Subject: Zoning By-law Amendment – 453 and 455 Coventry Road

File Number: ACS2023-PRE-PS-0018

Report to Planning and Housing Committee on 27 February 2023

Proposed rezoning of 453 and 455 Coventry Road (file: D02-02-21-0144)

Figure 2 - Potential new park locations north and south of Coventry Road

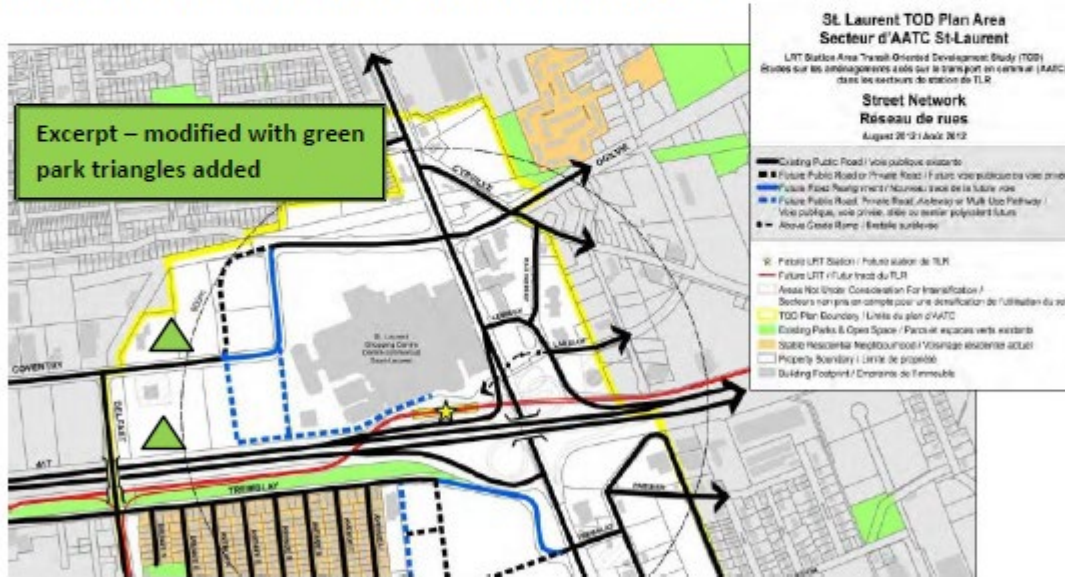
The below Figure 2, which includes a possible future road pattern for the general area, has two green triangles added to indicate potential for a public park located on the north side of Coventry Road and another on the south side, each serving redevelopment in those areas.

In light of the above policies of the Parks and Recreation Facility Master Plan and the Official Plan, it is important to start early to plan for these future park locations. On the next page is Figure 3 being a map of four possible park locations (there may be others). The identified letters signify the following:

Figure 4 – lands to be added to secondary plan

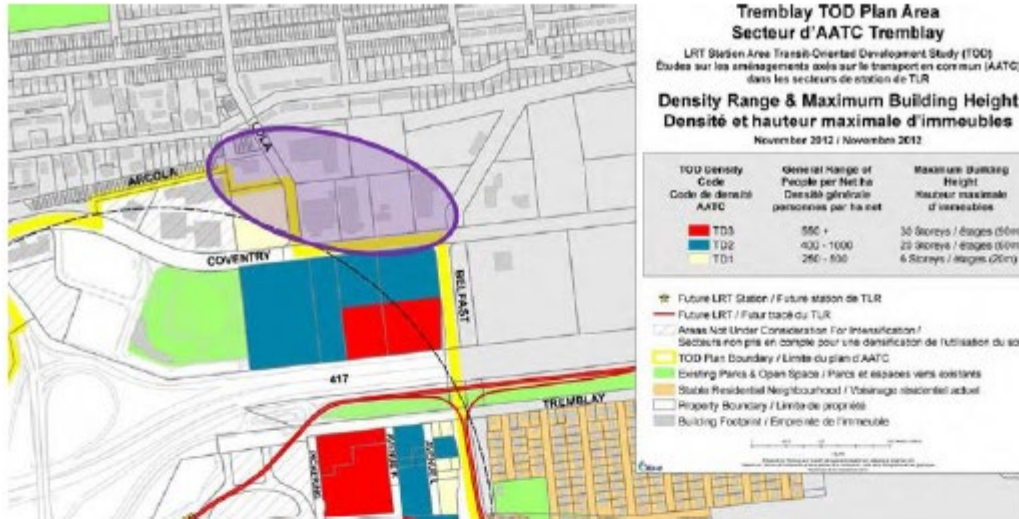
The below two map excerpts (Figures 4 and 5) were part of the Overbrook Community Association’s submission of comments to the City of Ottawa in March 2021 on the first draft of the proposed new Official Plan. They illustrated how the existing secondary plan (to conform to OP Schedule B2 – Inner Urban Transect) needed to be amended to add in the area in the purple oval; it not being either part of the current secondary plan nor the TOD Plan. The City indicated it would not be updating the Volume 2 secondary plans at this time (too excessive a work load).

Figure 5 – pathway connection needed

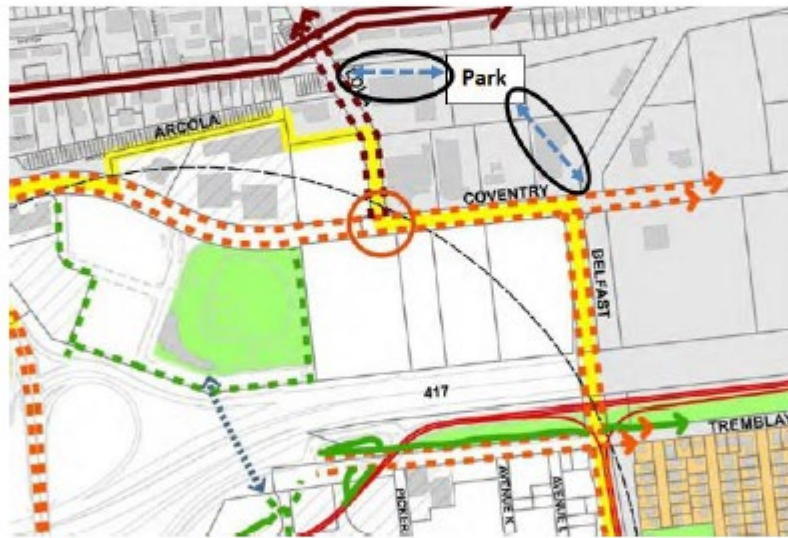
The second map (also next page) illustrated how there was a desire to see in the updated secondary plan an indication of the need to accommodate pathway connections to this relatively isolated Presland Park. Including is this possible connection to the east toward the land subject to this current rezoning application.
